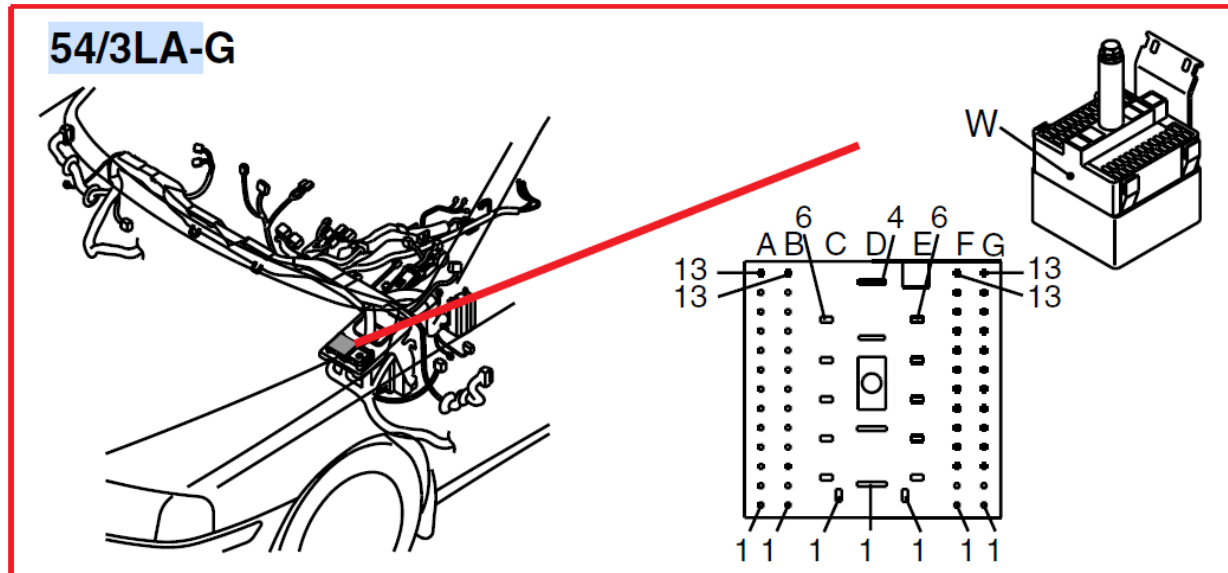
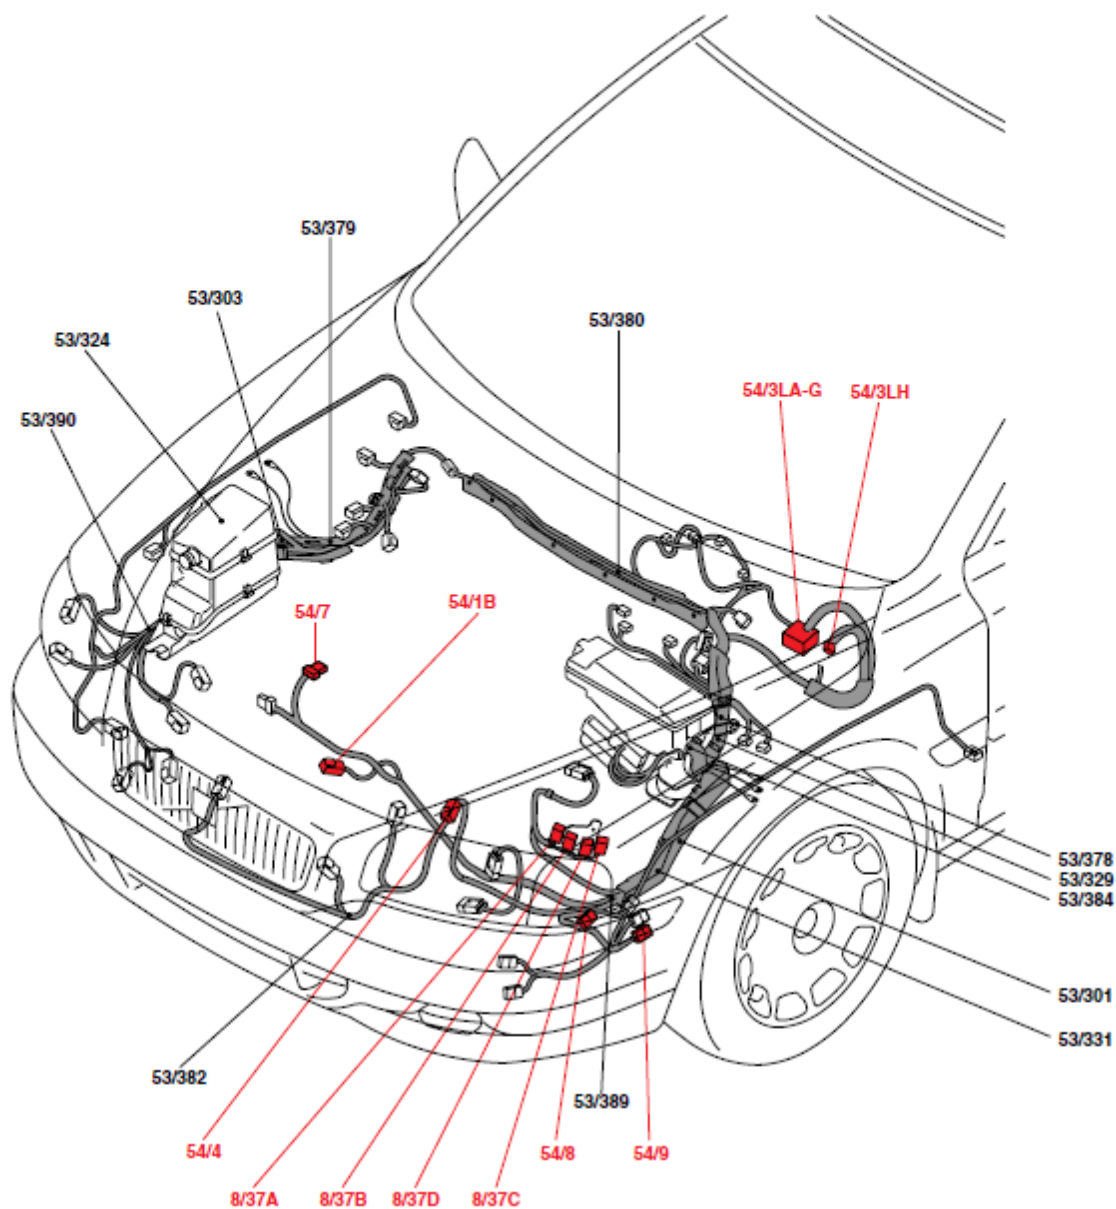
The CEM is a different design starting in 2005 so you need to also consider the primary connector(54/4LA-G) and signals between the CEM, BCM, ECM and TCM modules. 54/3 (2002 wiring diagram shown). Have you compared the pinout and wiring of this connector between model years? This is the connector where the engine harness connects to the passenger compartment harness (CEM).
